**Subject:** Supplemental Information

**Re:** Land Use Permitting

BULL RUN FILTRATION FACILITY

**WELLS WITHIN VICINITY OF FILTRATION FACILITY**

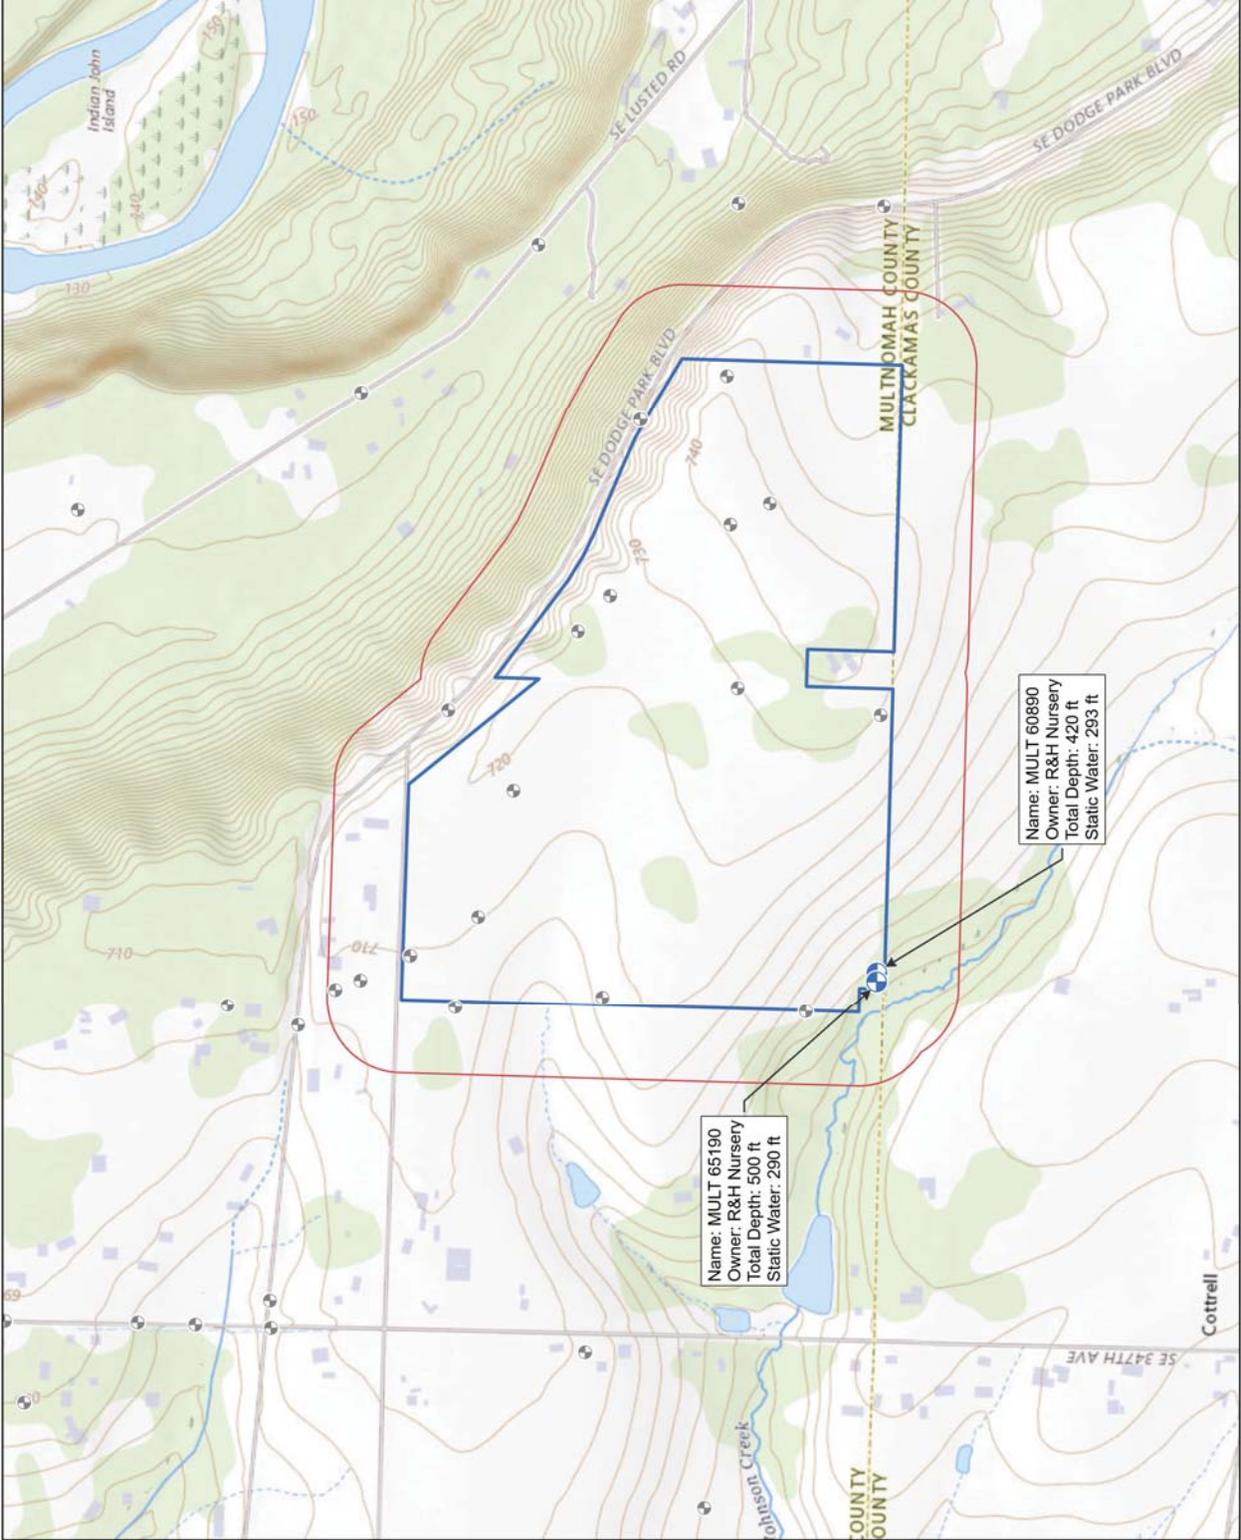
This letter provides additional information regarding existing water wells adjacent to the property upon which the Portland Water Bureau Filtration Facility is proposed (the “Filtration Facility Site”). in response to comments on that issue included in a memorandum prepared by True North Geotechnical dated June 28, 2023 (Exhibit E.21).

MULT 60890 and MULT 65190 were used as representative wells for static groundwater conditions within the 300-foot buffer. MULT 2594 has a reported original static groundwater elevation of 20 feet bgs on its 1972 Water Well Report, which is likely erroneous. While perched aquifers are documented within the area, it is unlikely a perched aquifer would create a shallow static groundwater condition within a well drilled to a depth of 420 feet. In addition, the artesian condition of approximately 400 feet required to achieve a static groundwater condition of 20 feet bgs has not been observed in other wells and geotechnical explorations at this location due to unfavorable geologic and topographic conditions. The well log for MULT 60890 indicates the well was reconditioned from MULT 2594. MULT 60890 has a recorded static water level of 293 feet bgs which is consistent with MULT 65190, and other deep wells within the area.

MULT 60890 and MULT 65190 are screened at a minimum of 290' below bgs. Though these wells are near the southwest corner of the property boundary, the wells are over 320 feet horizontal distance to the nearest Facility structure (Overflow Basin) and over 2,400 feet horizontal distance from the shaft and tunnels. The Overflow Basin is expected to be constructed using common earth moving equipment of excavator, dozer, and dump trucks. Vibrations from the construction equipment is predicted to be on the order of 0.002 to 0.004 inches per second. For the stronger but further vibrations from tunneling and shaft construction, the predicted vibrations at these wells are less than 0.004 inches per second. For comparison, the typical threshold for blasting vibrations to protect sensitive structures with lathe and plaster is 0.5 inches per second, over 100 times greater than what is predicted at the wells. Therefore, construction vibrations are not expected to impact the performance of private wells because the distances and depth of the wells is too far from the construction work areas to result in damage. In addition, the wells are constructed with steel casing, a material that is tolerant to vibration without damage.

Given the depth of the wells and the separation from surface activities for the Project, we do not anticipate that the construction will adversely impact the water quality or performance of the existing wells within 300-feet of the property.
